TO : All Bidders
FROM : Bob Lavey
PROJECT : Nogales High School Interim Locker and Restroom Portables
Project 230384.41
SUBJECT : Addendum 2
DSA : 04-123338 / File 33-13

ADDENDUM NO. 2

DRINKING FOUNTAIN - EXISTING CONDITIONS

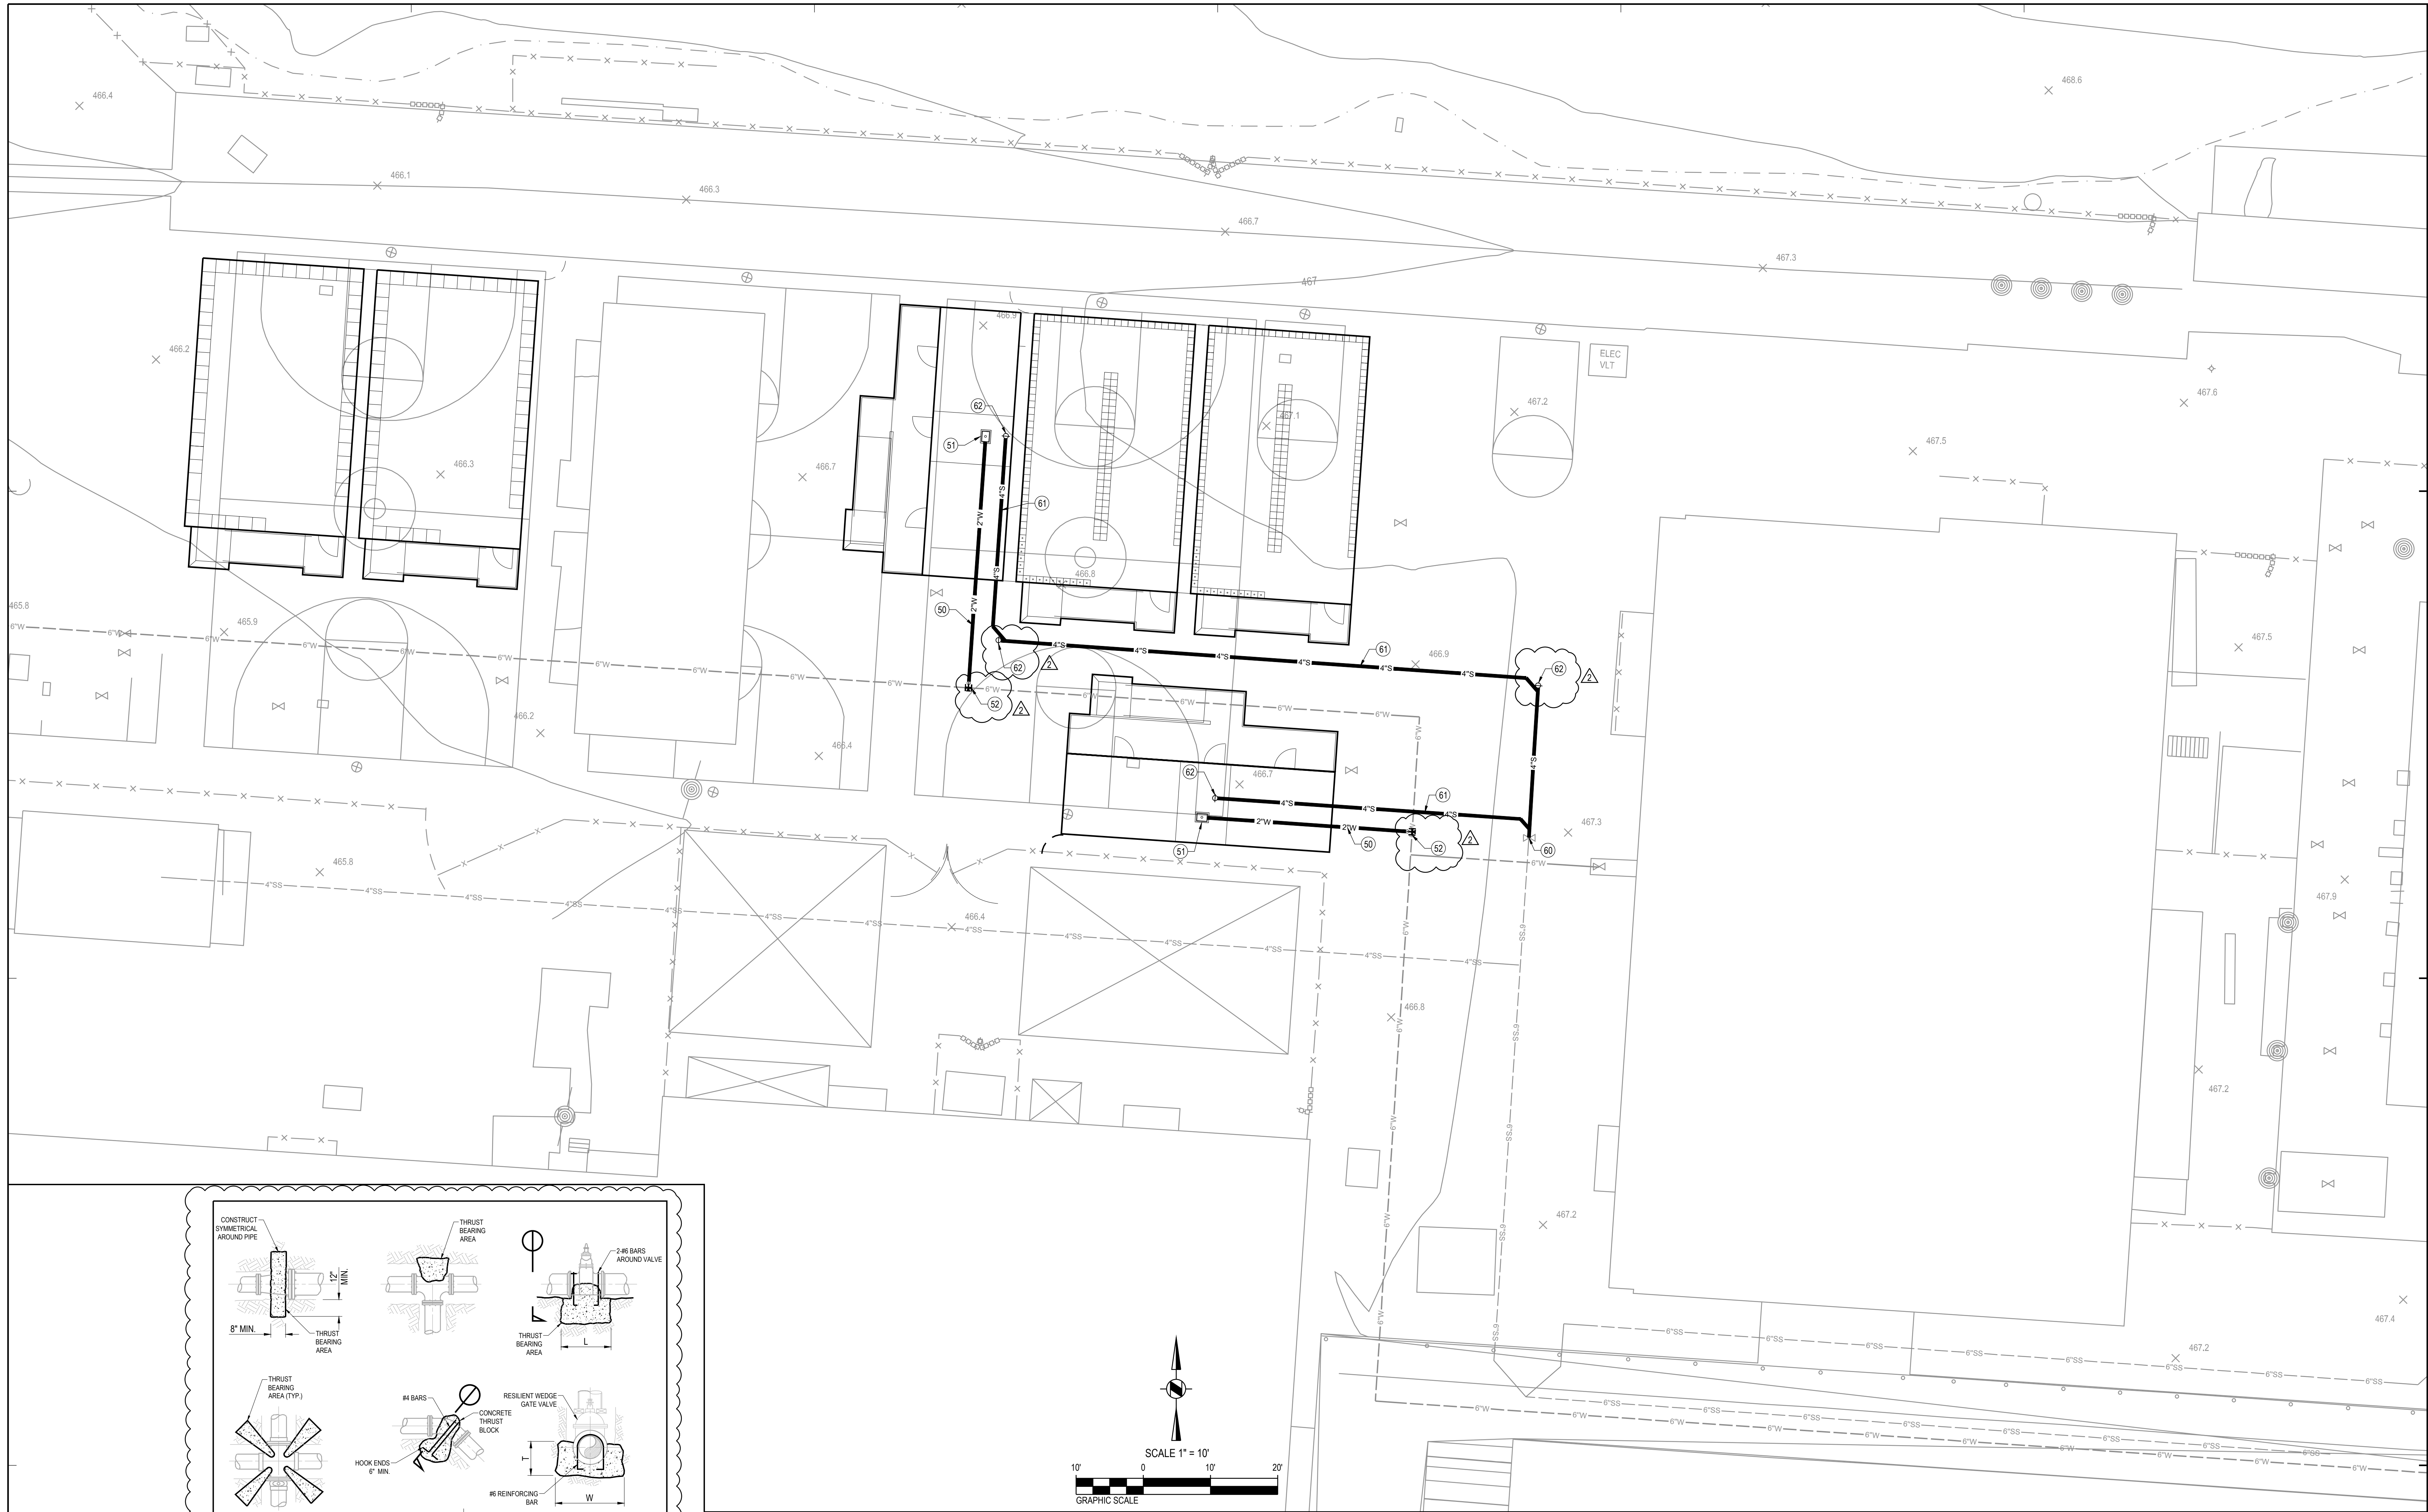
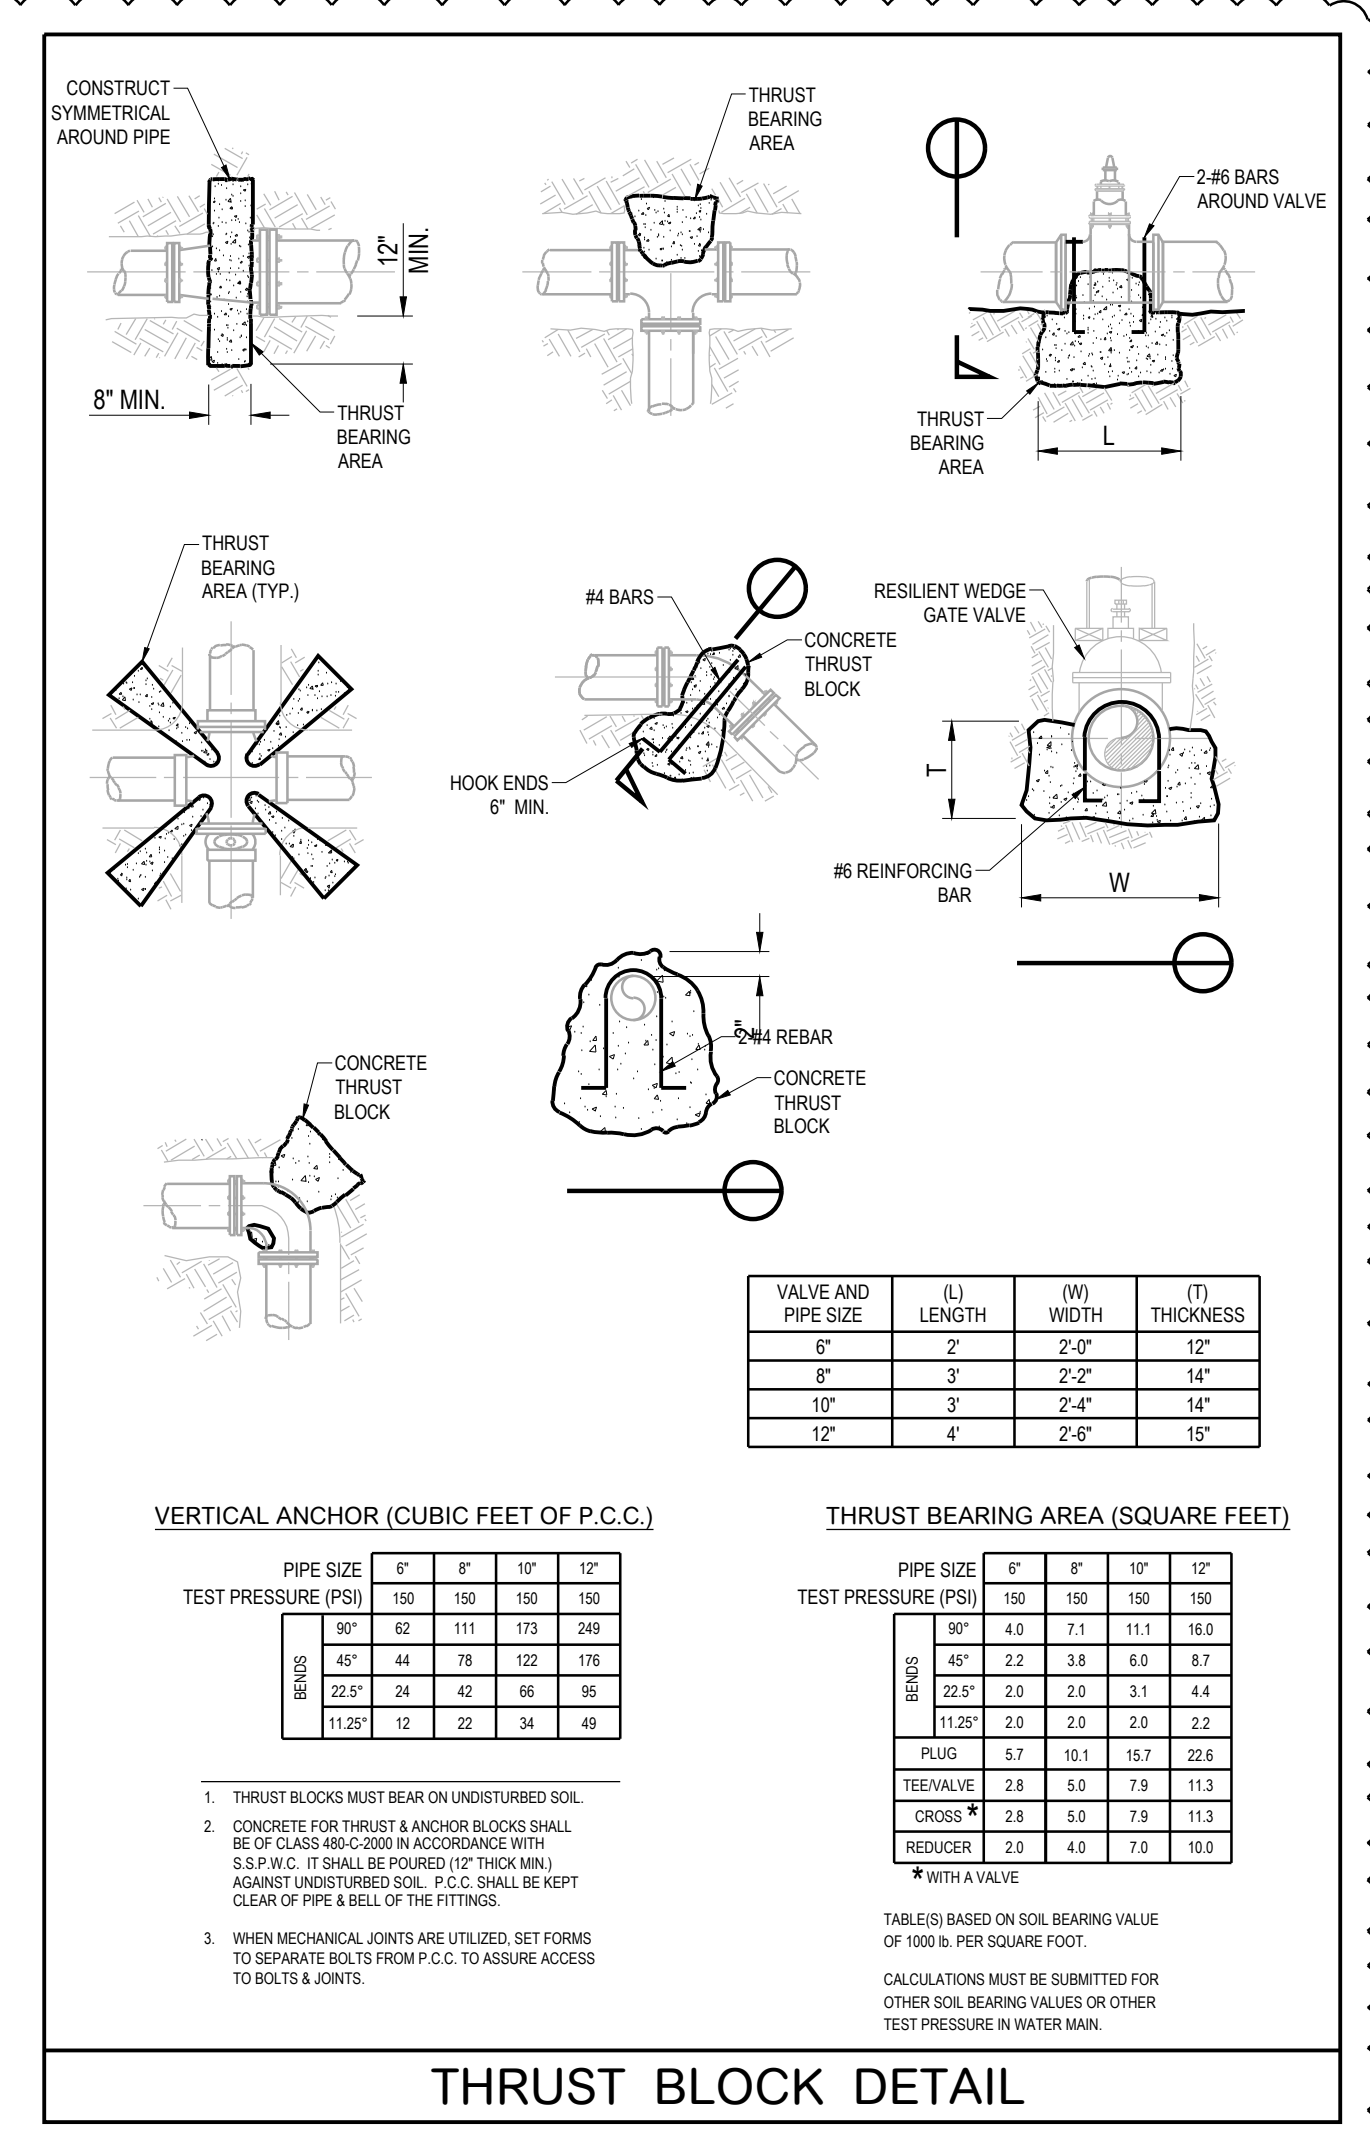
- A. Added two cleanouts and thrust blocks with a detail per the attached Drawing C1.01.

DRAWING NUMBER: **E0.1**

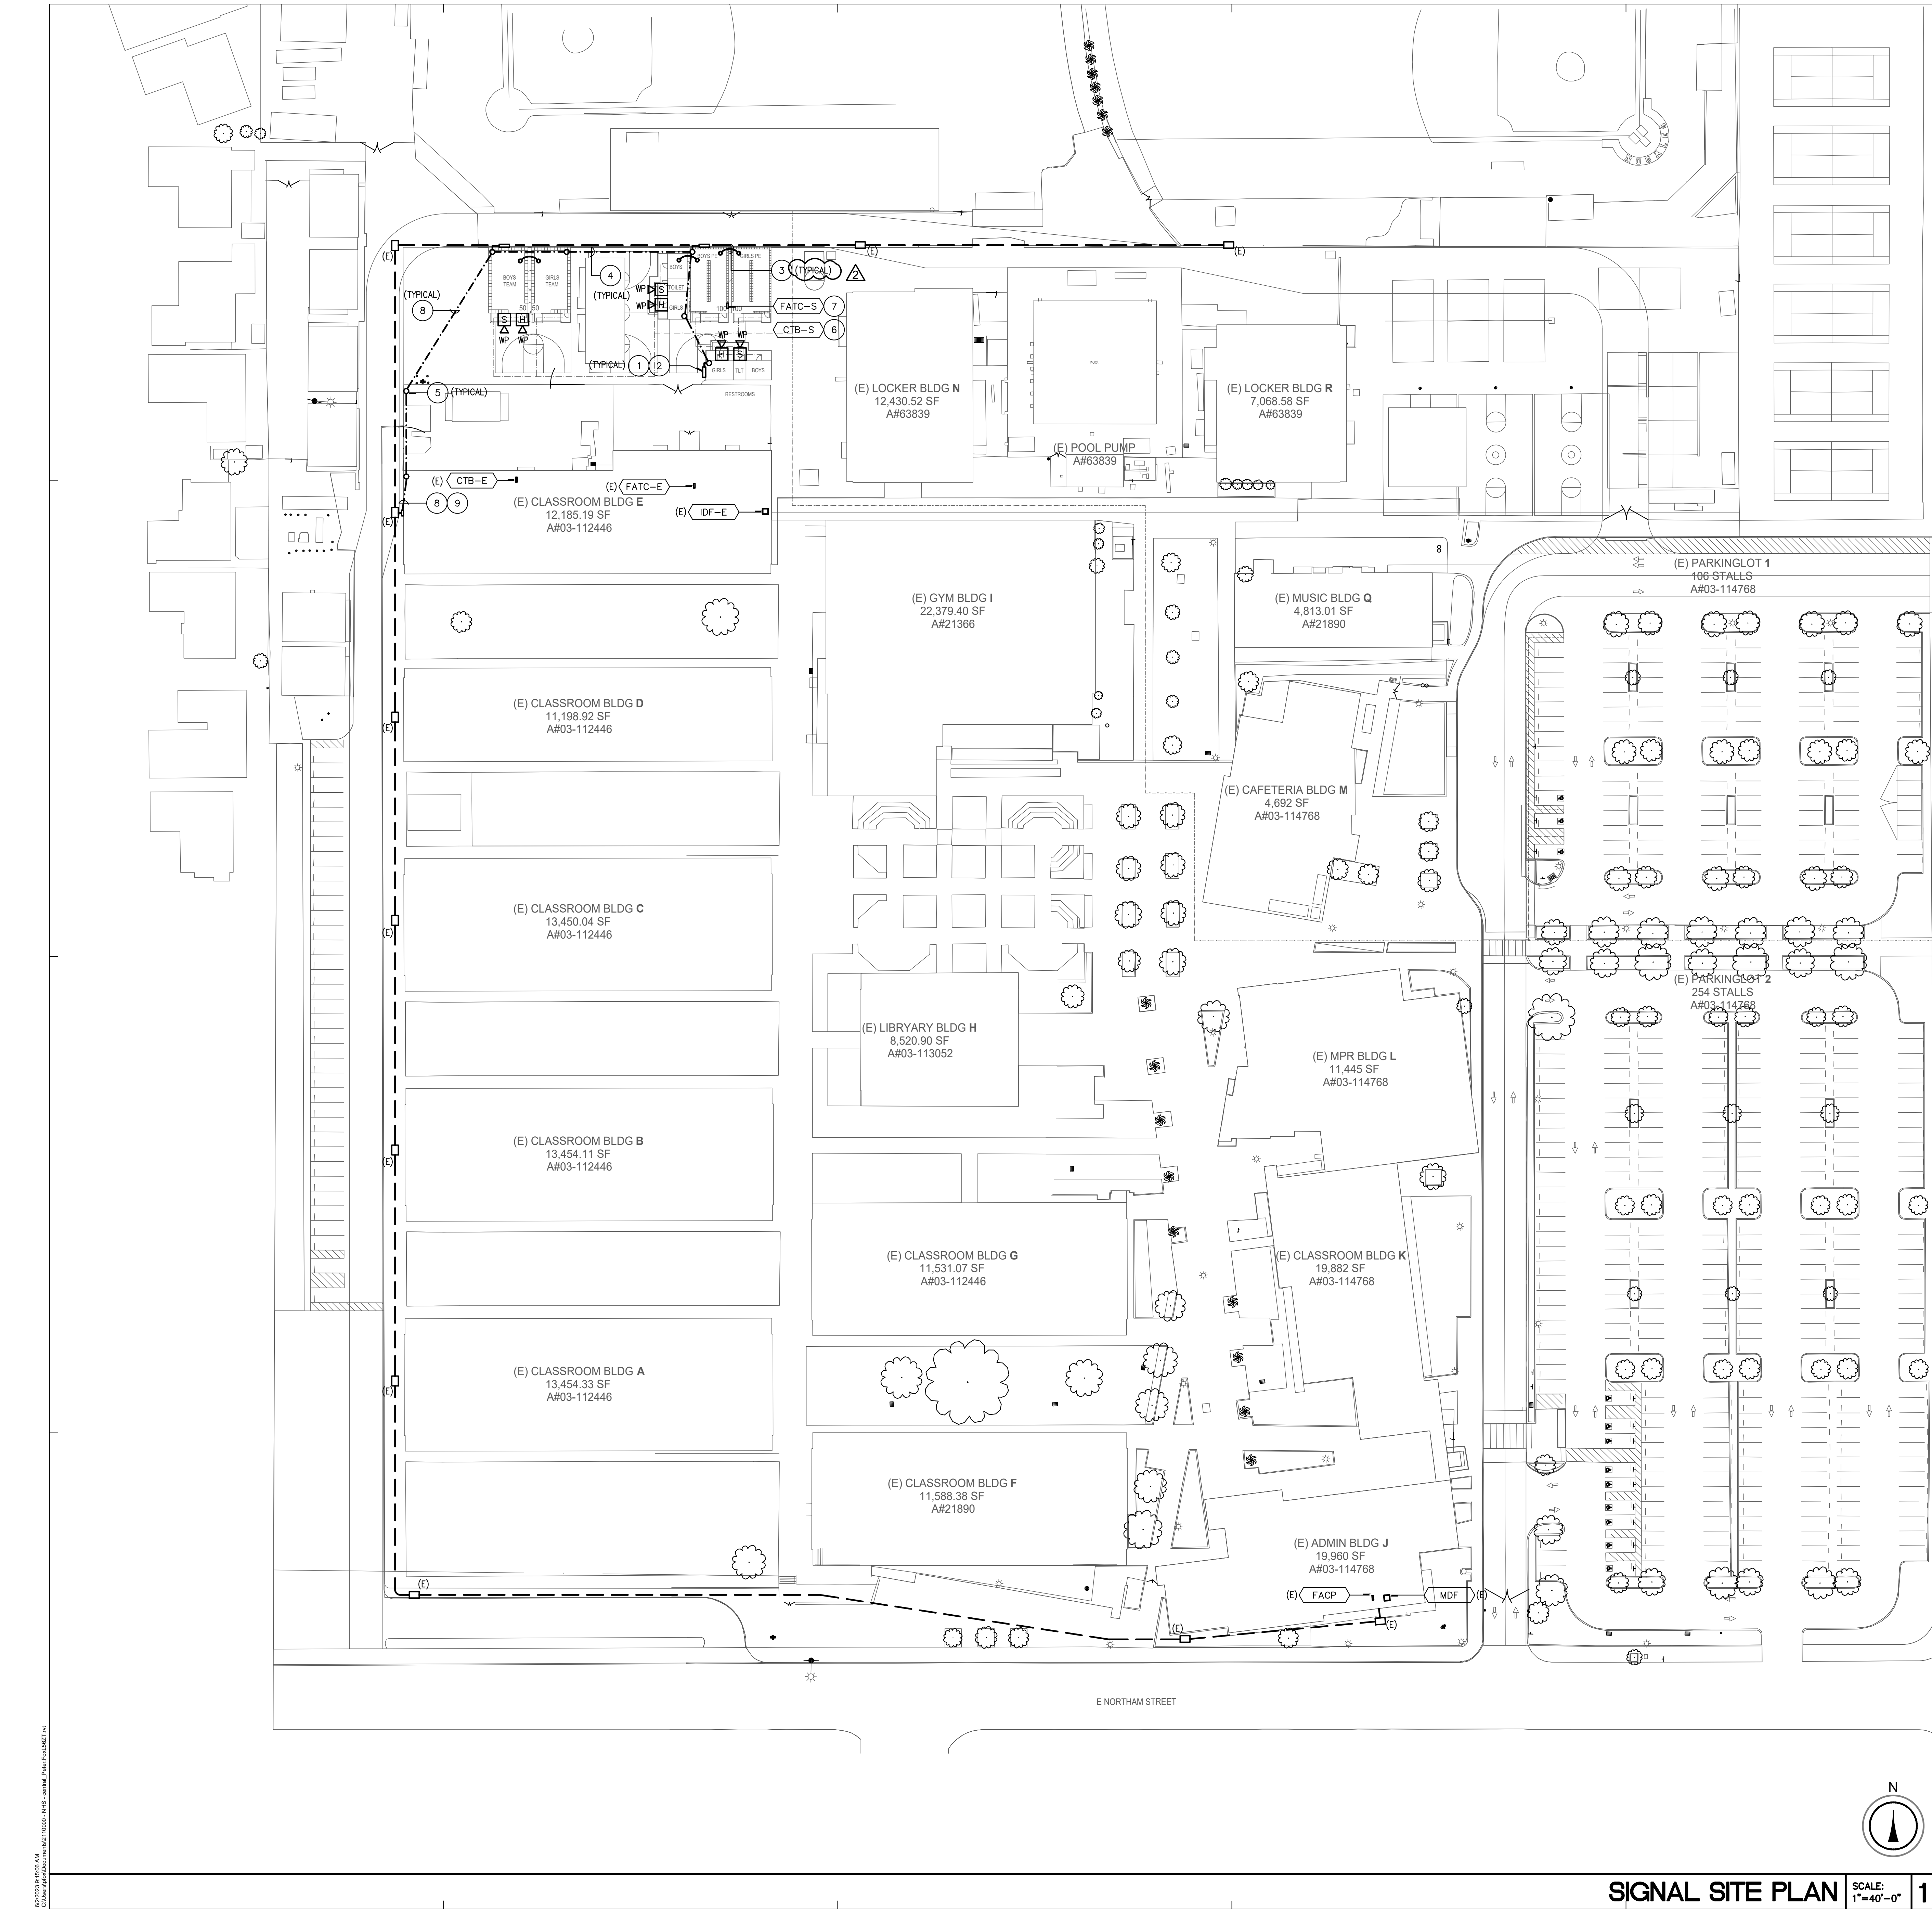
- A. Detail 1: Added Note 6 per the attached Drawing E0.1.
- B. Detail 2: Removed detail per the attached Drawing E0.1.
- C. Revised the Electrical Symbol List per the attached Drawing E0.1.
